Charlotte Historic District Commission Application for a Certificate of Appropriateness

ADDRESS OF PROPERTY 401 East Kingston Avenue, Dilworth Local Historic District HDC 2011-033

SUMMARY OF REQUEST Side Porch Enclosure

Existing Porch Scale 1* = 20 *

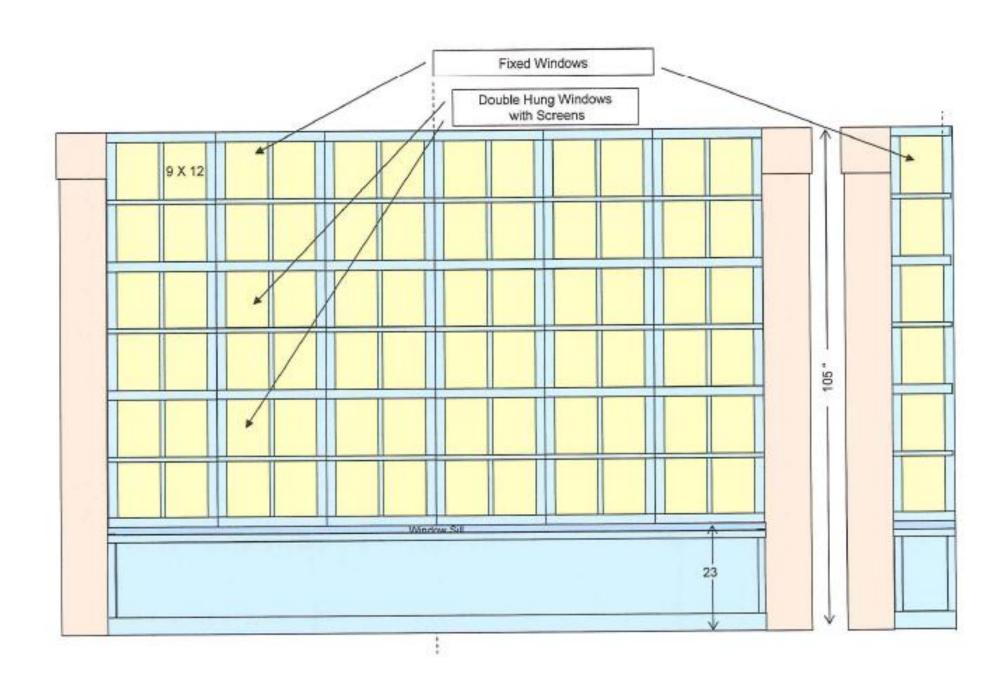
This proposal is for an alteration to a modern, infill house in the Dilworth Local Historic District. The porch, which is accessible only from the interior of the house, is on the least visible elevation of the house. Had this projection been shown as an enclosed space in the original approved plans for the house when it was built, it does not appear that it would have had a substantial impact on the approval granted by the HDC.

As shown on the attached plans, the detailing and plans for the enclosure are in keeping with the overall design vocabulary of the existing house.
